Application for Works Approval

Works Approval Number	W6862/2023/1
Applicant	Evolution Mining (Mungari) Pty Ltd
ACN	002 124 745
File number	DER2023/000674
Premises	Mungari Gold Operations Kundana Road, Kalgoorlie WA 6430 Legal description Part of mining tenements: L15/228, L15/246, L15/387, M15/688, M15/829, M15/830, M15/1287, M15/1407, M15/1741 and M15/1827 As defined by the coordinates in Schedule 2 of the works approval
Date of report	23 April 2024
Decision	Works approval granted

Figure 3: Location of monitoring bores

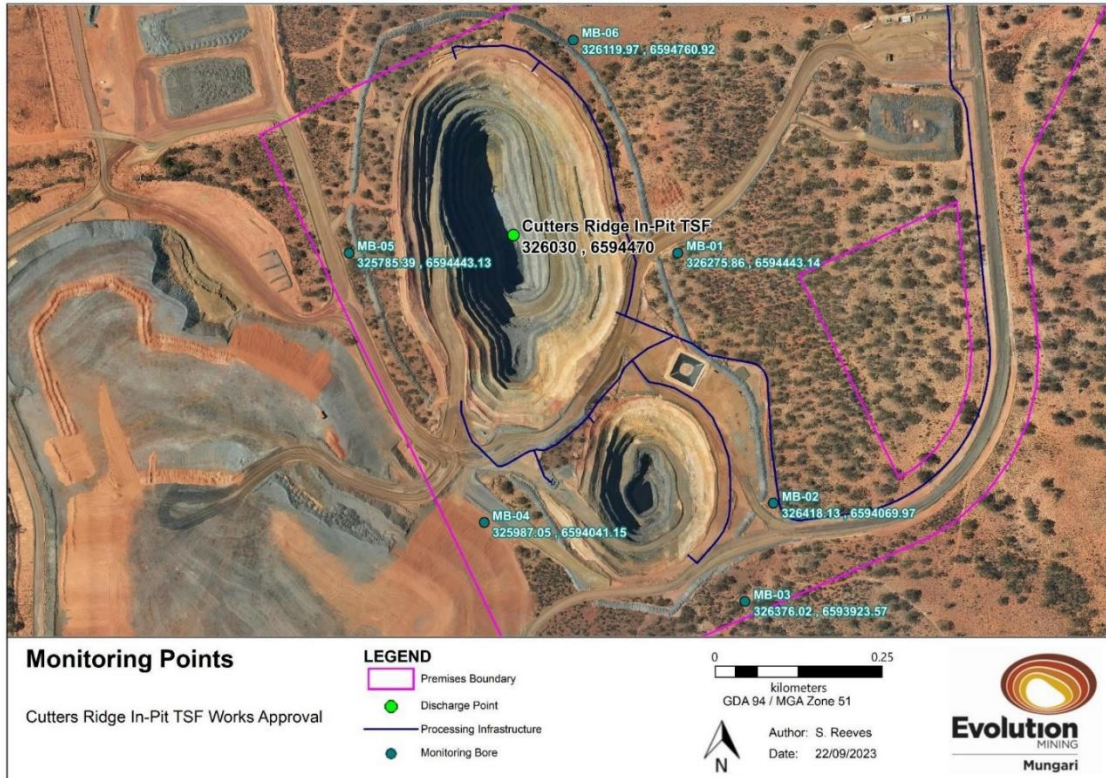
Section 4.1.1 outlines the works approval holder’s proposed controls. The applicant has proposed six monitoring bores to be constructed around the two mine voids contained within the TSF (**Error! Reference source not found.**). Internal technical advice has advised that the spatial distribution of these bores is appropriate to monitor standing water levels and water quality.
